UNITED STATES PATENT AND TRADEMARK OFFICE

APPLICATION NO.	FILING DATE	FIRST NAMED INVENTOR	ATTORNEY DOCKET NO.	CONFIRMATION NO.
10/679,019	09/30/2003	Keng Shui Wu	UCIP408	1518

Office Action Summary	Application No. 10/679,019	Applicant(s) WU, KENG SHUI	
	Examiner Katherine W. Mitchell	Art Unit 3677

DETAILED ACTION

Fig. 1 is a view in elevation of a fastener embodying my improvements and showing the locking projection continuous in a spiral arrangement in the direction of the screw threads and at an angle thereto.

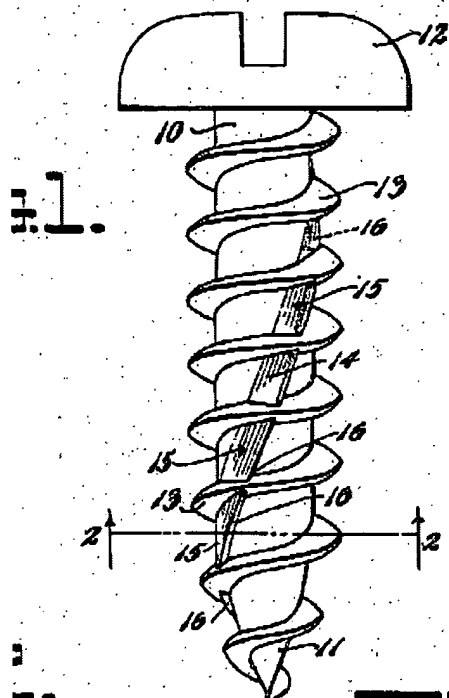
As noted above, Oestereicher teaches a screw with a head having a central recess (head 12 clearly has slot), a shank of a "proper" length (any length is proper for something) and screwing threads (13) and cutting threads (14/15), each of said screwing and cutting threads respectively having different guiding angles (fig 1 above, note claim objection above) and both threads having the same helical direction (above) and extending upward from a lower cone-shaped end portion to an upper end a "little lower" (relative term interpreted very broadly - little lower is relative) from said head, each of said screwing and cutting threads forming an angle phi (see ***Claim Rejections - 35 USC § 112 above***) --note that an angle phi is formed with respect to some {unnamed} line or plane. Note that any helical threads are considered to inherently perform some degree of screwing and cutting.

Re claim 3: As noted above, Oestereicher teaches a screw with a head (head 12), a shank extending from said head, said shank having a screwing thread (13) and cutting thread (14/15), both of said screwing and cutting threads respectively having different 1st and 2nd respective guiding angles (fig 1 above, note claim objection above) and both threads having the same helical direction.

Re claim 4: The screwing thread has a 1st pitch, the cutting thread has a second pitch, and the first pitch is smaller than the second pitch -- see Fig 1 above - the screwing thread 13 is clearly of a smaller pitch than the cutting thread 14/15.

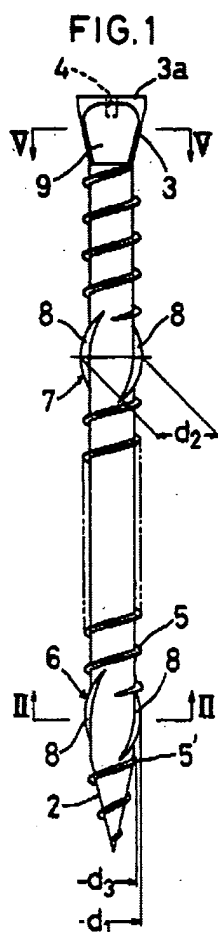
As noted above, Gotoh teaches a screw with a head 3a having a central recess 4, a shank of a "proper" length (any length is proper for something) and screwing threads (5,5') and cutting threads (6/7/8), each of said screwing and cutting threads respectively having different guiding angles (fig 1 above, note claim objection above) and both threads having the same helical direction (above) and extending upward from a lower cone-shaped end portion to an upper end a "little lower" (*relative term interpreted very broadly - little lower is relative*). Also note that applicant did **not** claim that cutting threads were continuous) from said head, each of said screwing and cutting threads forming an angle phi (see **Claim Rejections - 35 USC § 112 above**) --note that an

angle phi is formed with respect to some {unnamed} line or plane. Note that any helical threads are considered to inherently perform some degree of screwing and cutting.

Re claim 3: As noted above, Gotoh teaches a screw with a head 3, a shank extending from said head, said shank having a screwing thread (5,5') and cutting thread (6/7/8), both of said screwing and cutting threads respectively having different 1st and 2nd respective guiding angles (fig 1 above, note claim objection above) and both threads having the same helical direction.

Re claim 4: The screwing thread has a 1st pitch, the cutting thread has a second pitch, and the first pitch is smaller than the second pitch -- see Fig 1 above - the screwing thread 5,5' is clearly of a smaller pitch than the cutting thread 6/7/8.
